UNITED STATES PATENT AND TRADEMARK OFFICE

APPLICATION NO.	FILING DATE	FIRST NAMED INVENTOR	ATTORNEY DOCKET NO.	CONFIRMATION NO.
10/645,667	08/22/2003	Takashi Koba	2018-768	8419
23117	7590	01/31/2006	EXAMINER	
NIXON & VANDERHYE, PC 901 NORTH GLEBE ROAD, 11TH FLOOR ARLINGTON, VA 22203			DWIVEDI, VIKANSHA S	
			ART UNIT	PAPER NUMBER
			3746	
DATE MAILED: 01/31/2006

SUPPLEMENTAL Office Action Summary	Application No. 10/645,667	Applicant(s) KOBA ET AL.	
	Examiner Vikansha S. Dwivedi	Art Unit 3746

Above Figure is Figure 3 of Mukaidani. The portion between A and B is a groove as disclosed in Claim 1.

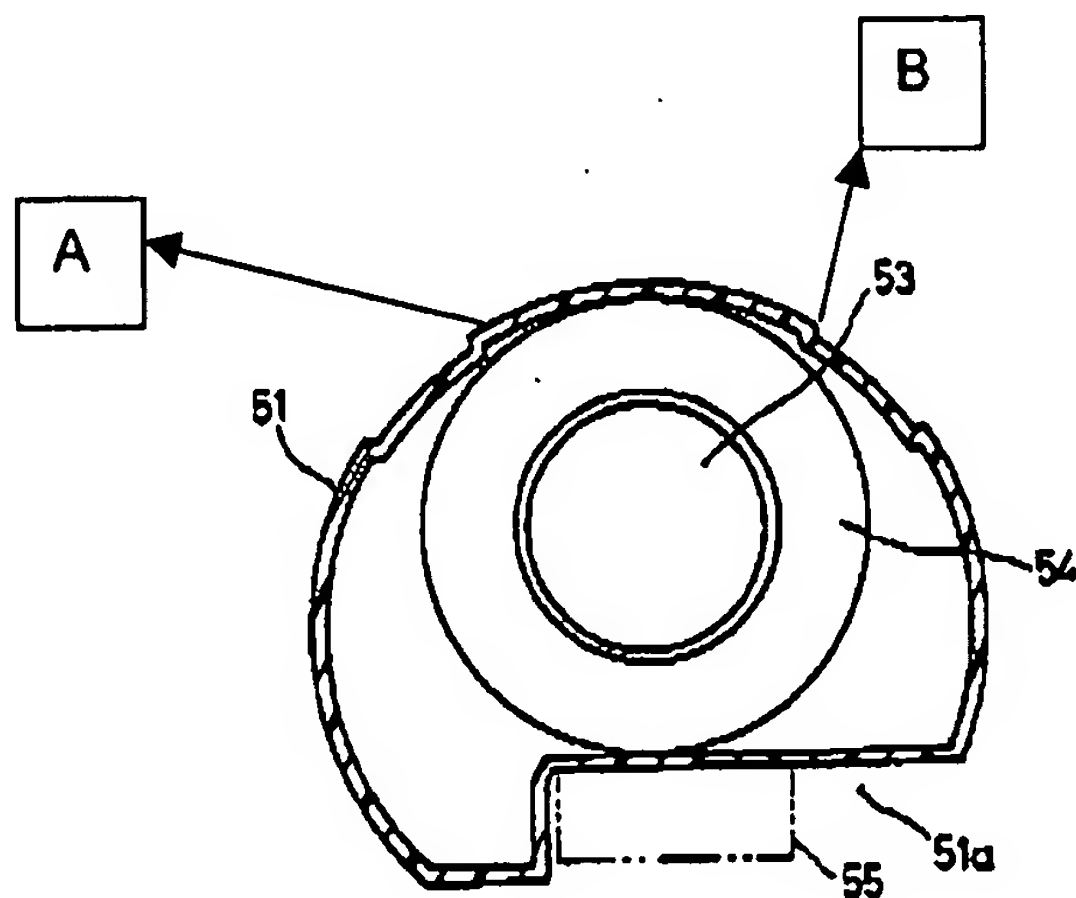
Mukaidani teaches a fuel tank (1, Figure 2 also described on Page 2) with a fuel pump (21, Figure 1). Mukaidani refers to his pump as "fuel pump" not "electrical fuel pump", though it is clear from the description and the Figure 2 which shows an electrical connector (14, Figure 2) that it is indeed an electrical fuel pump. It also discloses a connecting member as shown in figure 2 (42) and described on page 3, line 47 of the text, which Mukaidani refers to as connecting pipe.

Mukaidani sets forth a device as described above, which is substantially analogous to the claimed invention. The fuel supply device disclosed by Mukaidani differs from the claimed invention in that there is no explicit teaching of relative movement between the cover and the pump unit. Supporting portion lacks a through hole that penetrates through and receives the connecting member. Also, the supporting portion is not slidably engageable with the connecting member.
